Access Compliance Report Public Rights-of-Way (Curb Ramps)

Intersection ID: 10024355 Main Street: CRESCENT EXECUTIVE DR Cross Street: N/A Location: NE **ADA ID: AF4597A761AB** Ramp Type: PerpDiag Initial Pass/Fail: Fail **Overall Compliance: No Severity Score:** 12.5

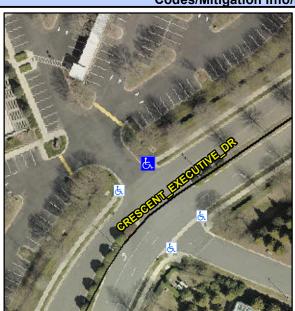
R304.5.3

Compliance Description Data		Comp	liance Description	Data	
N/A	Ramp Length (in)	108.0	Yes	Ramp Slope (%)	7.3
Yes	Ramp Width (in)	60.0	No	Ramp XSlope (%)	5.9
N/A	Flare Type LT	N/A	N/A	Flare Type RT	N/A
N/A	Flare Slope LT (%)	N/A	N/A	Flare Slope RT (%)	N/A
N/A	Flare Traversable LT?	N/A	N/A	Flare Traversable RT?	N/A
N/A	Landing Length (in)	N/A	N/A	DWS Provided?	N/A
N/A	Landing Width (in)	N/A	N/A	DWS Contrast?	N/A
N/A	Landing Slope (%)	N/A	N/A	DWS Length (in)	N/A
N/A	Landing X Slope (%)	N/A	N/A	DWS Full Width?	N/A
N/A	Landing Curb? (Y/N)	N/A	N/A	DWS Offset (in)	N/A
N/A	Shared Landing?	N/A			
N/A	Gutter Ponding?	N/A	N/A	Gutter Slope (%)	N/A
N/A	Gutter Lip Ht (in)	N/A	N/A	Gutter X Slope (%)	N/A
N/A	Painted X Walk1?	No	N/A	Painted X Walk2?	No
	X Walk 1 Direction	To SW		X Walk 2 Direction	To SE
N/A	X Walk 1 Width (in)	N/A	N/A	X Walk 2 Width (in)	N/A
	X Walk 1 Slope (%)	4.6		X Walk 2 Slope (%)	0.1
	X Walk 1 X Slope (%)	4.6		X Walk 2 X Slope (%)	1.8

Remove & Replace Curb Ramp With **Two New Directional Ramps or** Equivalent.
